AIR - HPT/LPT ACC VALVE ACTUATOR - INSTALLATION OF PIN RETAINER ON SERVO VALVE -
CATEGORY CODE 3 - MOD.ENG-75-0027

V2500-ENG-75-0027

AIR - V2500 - HP/LP ACC ACTUATOR, PART NUMBER 5860017-109, -111, -113 AND -114.
INCORPORATION OF PIN RETAINER CLIP ON SERVO VALVE.

5860017-75-66

Family Tree - HP/LP Turbine ACC Valve Actuator Ref. Catalog Sequence No. 75-24-52, Fig
01, Item 100
Fig.1

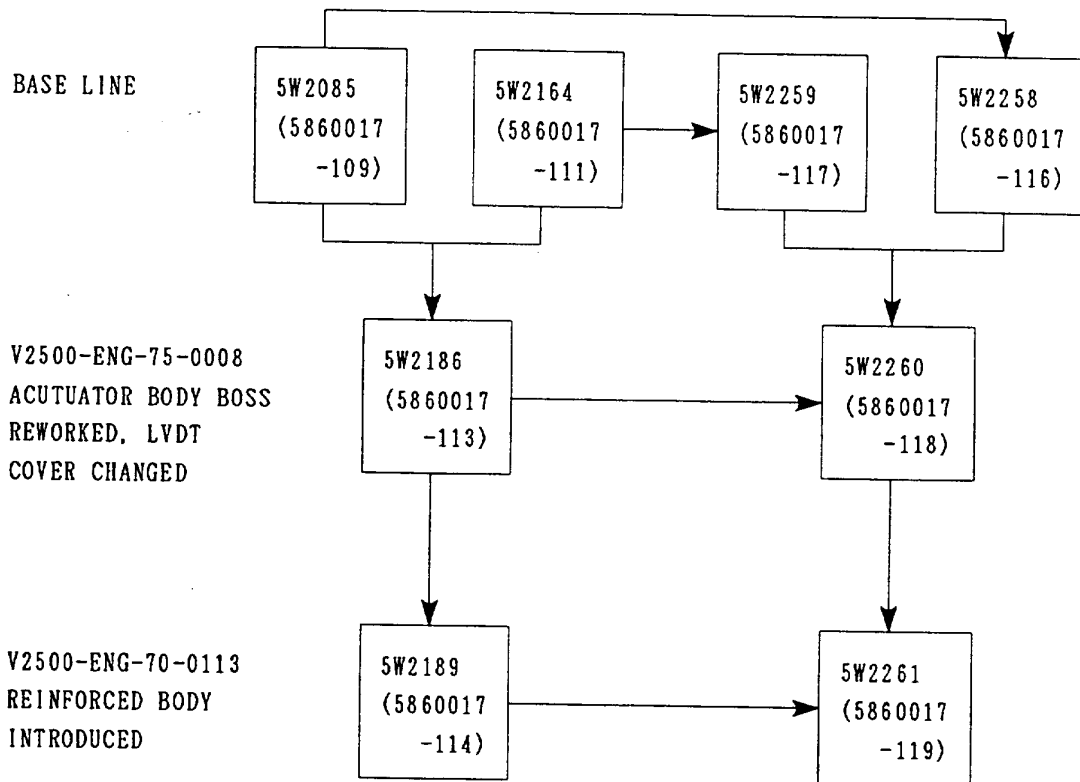
V2500-ENG-75-0027
PIN RETAINER ADDED
TO ABEX SERVO
VALVE

:ACC ACTUATOR WHICH IS ACCOMPLISHED THIS MODIFICATION, IS
TO BE RE-IDENTIFIED FROM LEFT HAND PART NUMBER FLOW CLUSTER
TO RIGHT HAND PART NUMBER FLOW CLUSTER.
PART NUMBERS IN RIGHT HAND PART NUMBER FLOW CLUSTER SHOW
ACC ACUTUATORS WHICH ARE ACCOMPLISHED THIS MODIFICATION.

- (1) Do a modification of the 5W2085, 5W2164, 5W2186 and 5W2189 HPT/LPT ACC Valve Actuator and reidentify as 5W2258, 5W2259, 5W2260 or 5W2261 by the approved procedure in Reference (1), Parker Hannifin Service Bulletin.

Abex and BW/IP Servo Valves
Figure 1

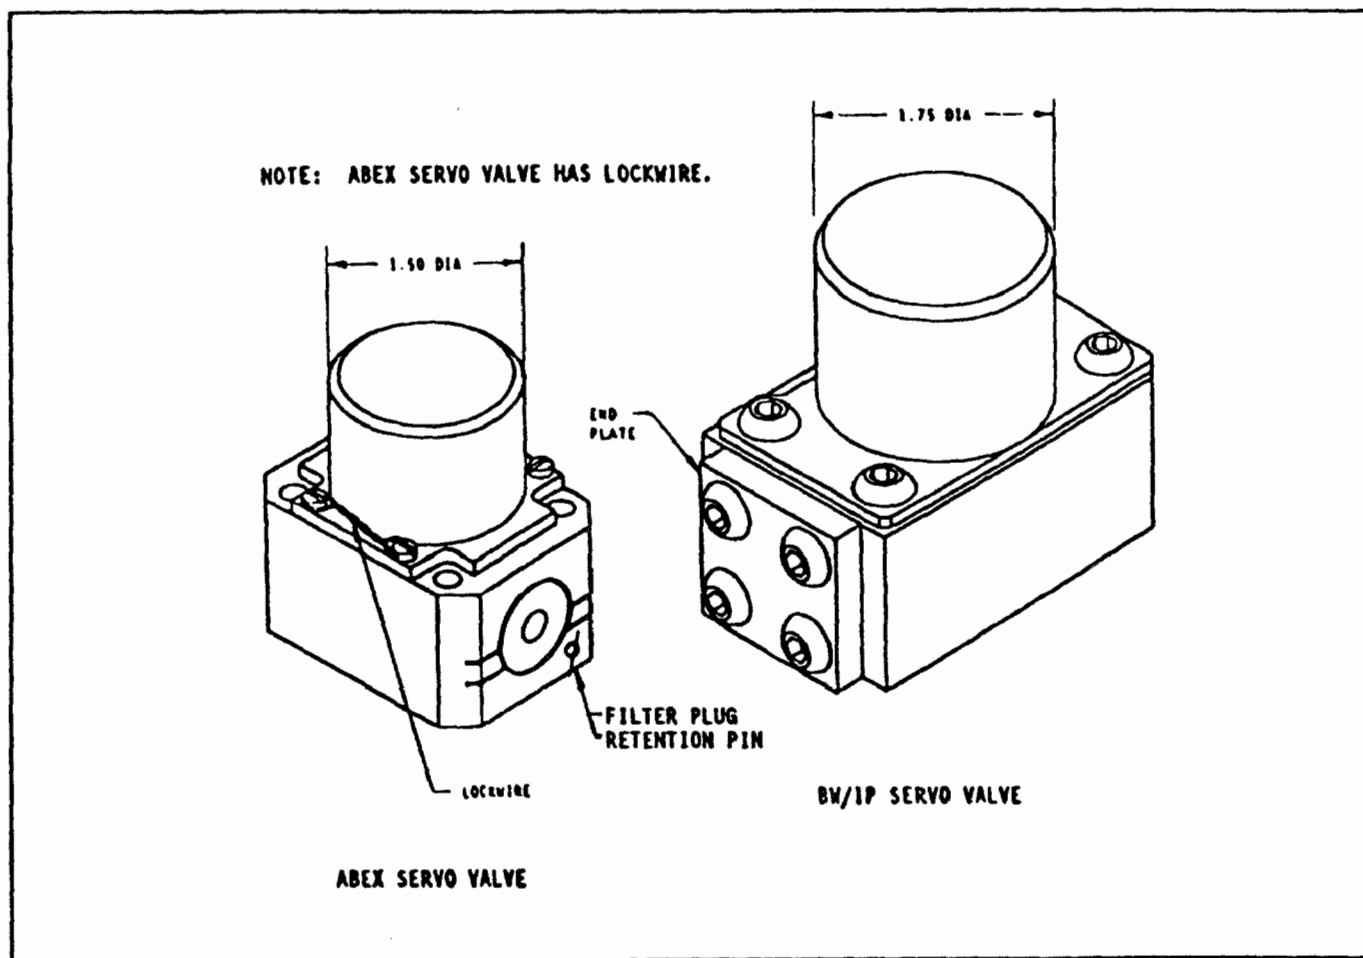
A. Determine if the servo valve, Part Number 5863057-101 is manufactured by Abex or BW/IP. (See Figure 1 and the servo valve nameplate.)

- (1) If the 5863057-101 servo valve was manufactured by BW/IP, this service bulletin has been accomplished. Operators shall proceed to paragraph 2.E. and reidentify the Actuator accordingly.
- (2) If the 5863057-101 servo valve was manufactured by Abex Aerospace (Vendor Number 75250), operators shall perform an additional check for the servo valve filter plug retention pin and ensure that it is intact per Figure 2. If the filter plug retention pin is missing, operators shall return the Actuator to Parker for accomplishment per paragraph 1.G.(4). If the filter plug retention pin is NOT missing, proceed to the next paragraph.

Filter Plug Retention Pin Location
Figure 2

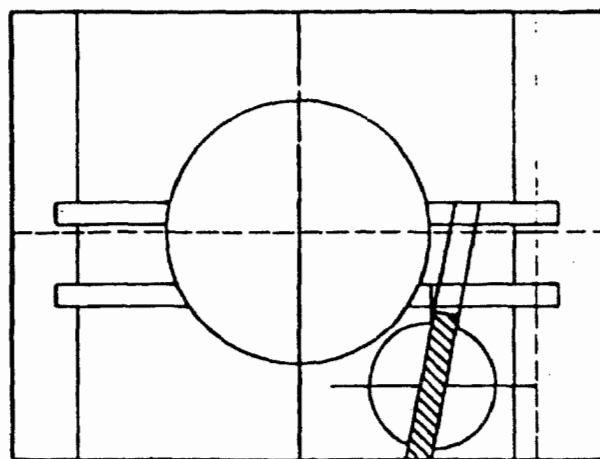
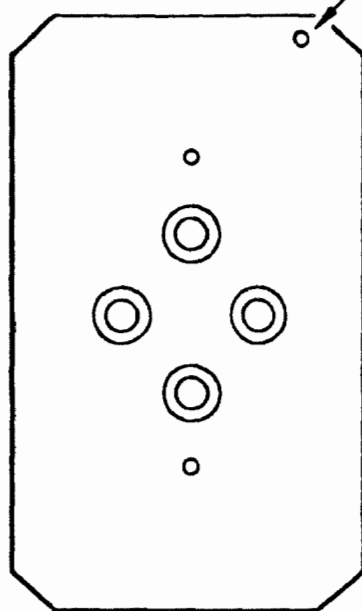
<u>TASK</u>	<u>MAN HOURS</u>
(a) Visual inspection for suspect Abex servo valve per Figure 1.	0.25
<u>NOTE 1</u> : If an Abex servo valve is located, visually check and ensure that the pin is intact per Figure 2 and Figure 3 (Before View). If the filter plug retention pin is missing, return the Actuator to Parker Hannifin Corporation per paragraph 1.G.(4) in this service bulletin. Accomplishment of this service bulletin will be completed by Parker.	
<u>NOTE 2</u> : If a BW/IP servo valve is located, the pin retainer clip installation is <u>NOT</u> necessary. Proceed to paragraph 2.E. and reidentify the Actuator accordingly.

Before and After Visual Inspection
Figure 3

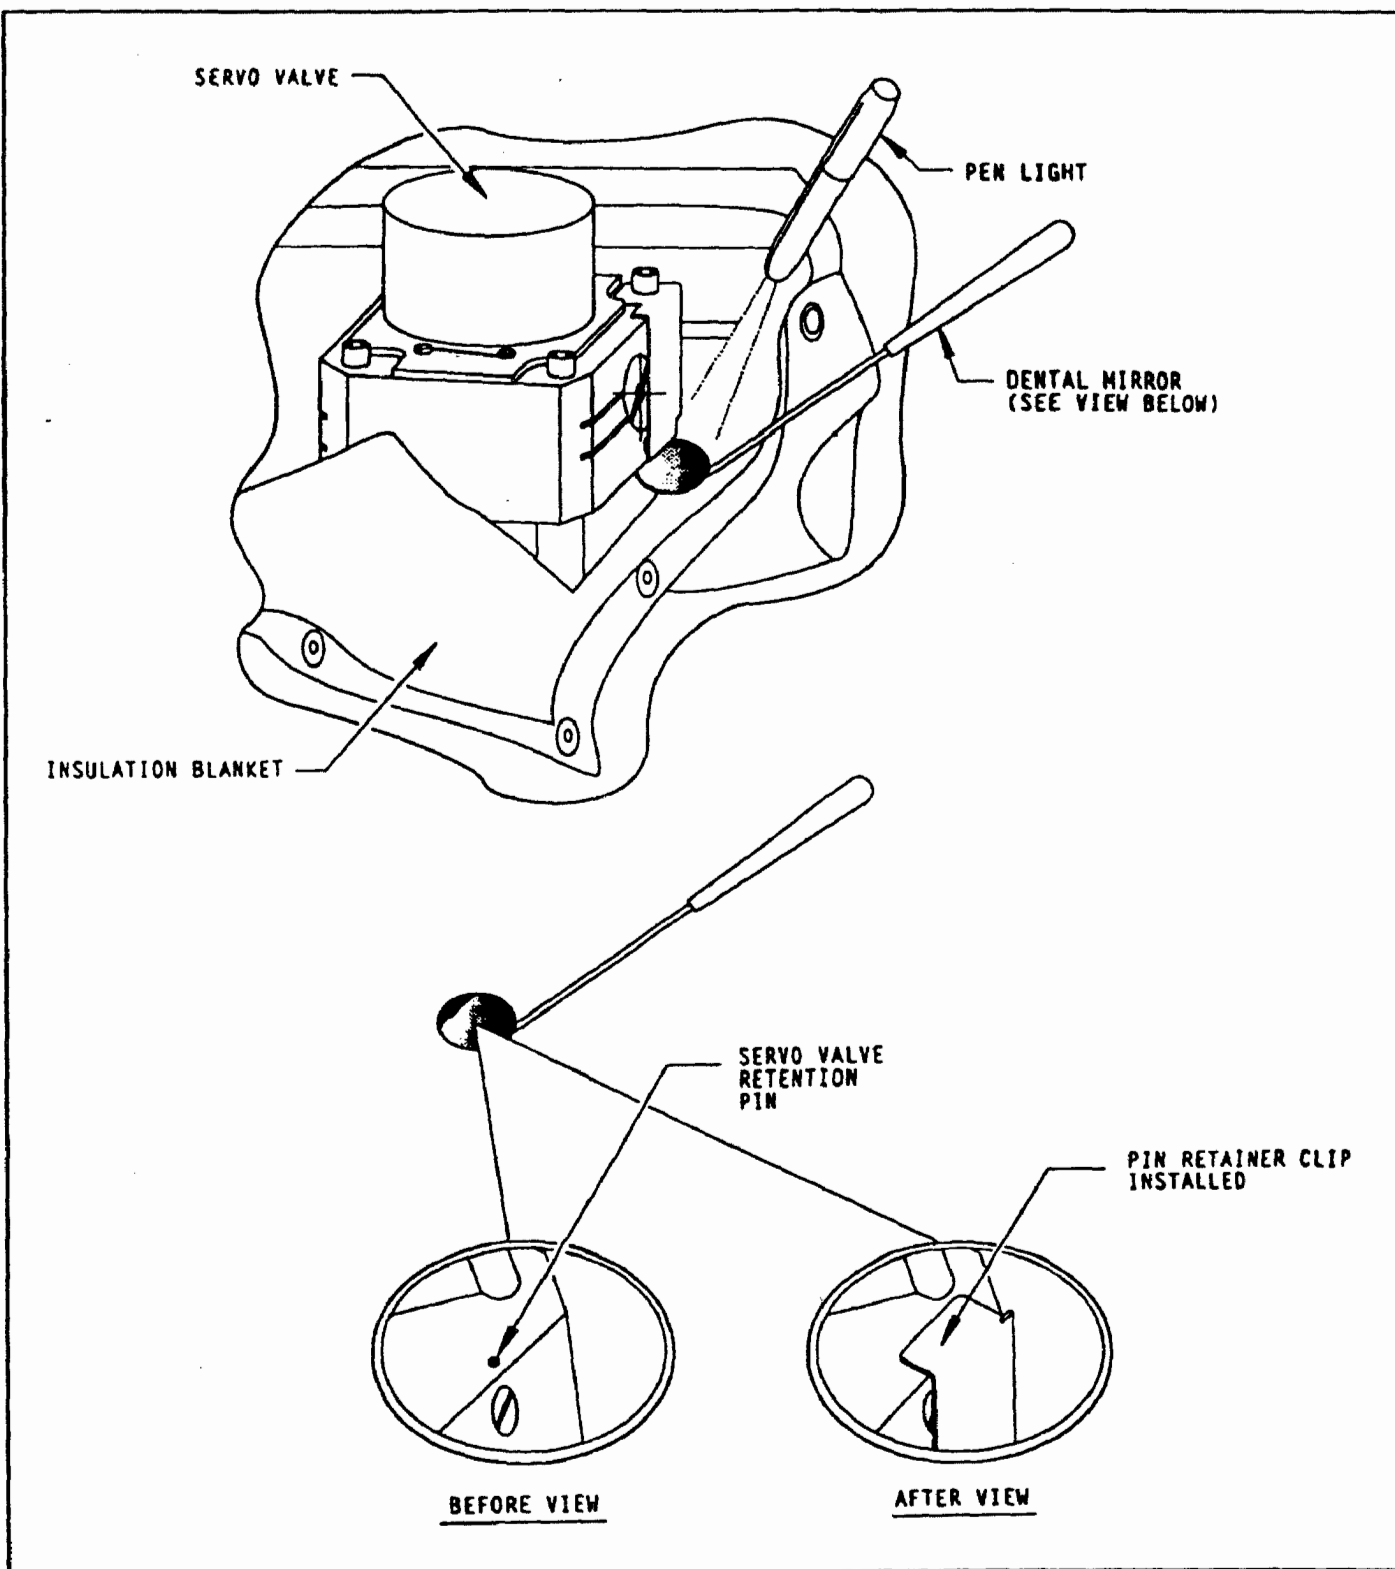
(e) Visual inspection for proper installation of pin retainer clip over retention pin per Figure 3 (After View).*	0.25
(f) Reidentification of the Actuator per paragraph 2.E.	0.25

- D. Reinstall screw (110) and torque 20 to 24 in.lb (2.3 to 2.6 Nm). Perform a visual inspection per Figure 3 (After View) in this service bulletin, using a dental mirror (or equivalent) and a pen light.

Pin Retainer Clip Location on Abex Servo Valve
Figure 4

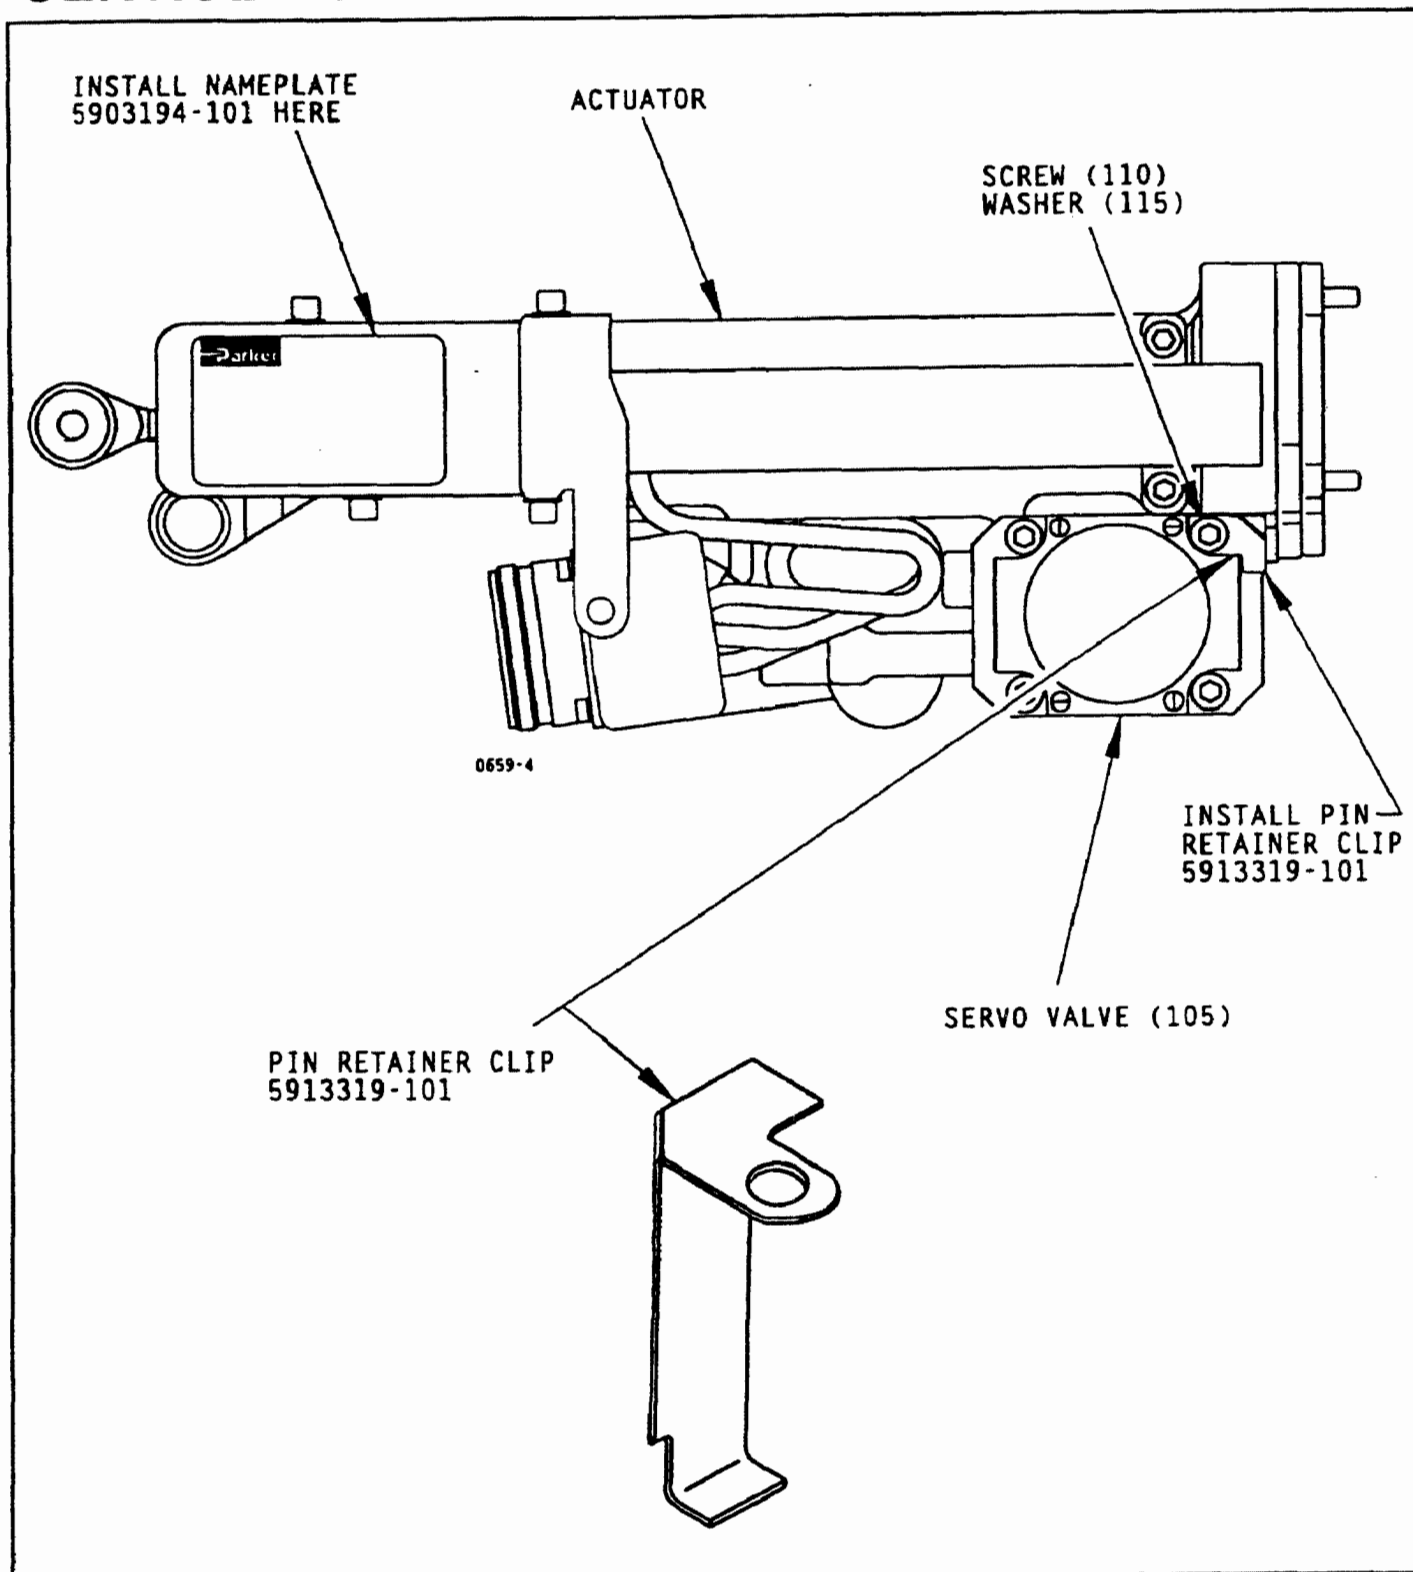
(b) Removal of lockwire and opening of insulation blanket.	0.10
(c) Removal of Abex servo valve screw and washer per Figure 4.	0.25
(d) Installation of pin retainer clip and screw on Abex servo valve per Figure 4.	0.25

- B. Unless otherwise noted, refer to Parker Hannifin Corporation Component Maintenance Manual (CMM) 75-24-52 IPL Figure 1 for item numbers used in these instructions.
- C. Installation of pin retainer clip, Part Number 5913319-101, on Abex servo valve:
- (1) Refer to the DISASSEMBLY section of CMM 75-24-52, remove lockwire and open the insulation blanket (5) to access the servo valve.
 - (2) Remove one screw (110) and one washer (115) from the Abex servo valve per Figure 3 in this service bulletin. Discard washer.
 - (3) Install the pin retainer clip, Part Number 5913319-101, as noted in Figure 3 and as follows:
 - (a) Starting from the bottom side first, position pin retainer clip, Part Number 5913319-101, on inner right corner of Abex servo valve (105).
 - (b) Slide fit the pin retainer clip, Part Number 5913319-101, over the top side corner and into position with the screw hole.

NOTE: The spring tension of the pin retainer will allow it to stay in place and permit a secure fit on the Abex servo valve.

- 1) Operators shall clean the stenciled nameplate on the LVDT cover. Part Number 5883820-101, with de-natured alcohol or equivalent.
- 2) Position and install the new nameplate, Part Number 5903194-101, over the existing nameplate on the LVDT cover. Part Number 5883820-101, per Figure 4 in this service bulletin.

- 1) Operators shall peel away the old nameplate and clean the area on LVDT cover. Part Number 5883820-103, with de-natured alcohol or equivalent.
- 2) Position and install the new nameplate, Part Number 5903194-101, in the same location on the LVDT cover. Part Number 5883820-103, per Figure 4 in this service bulletin.
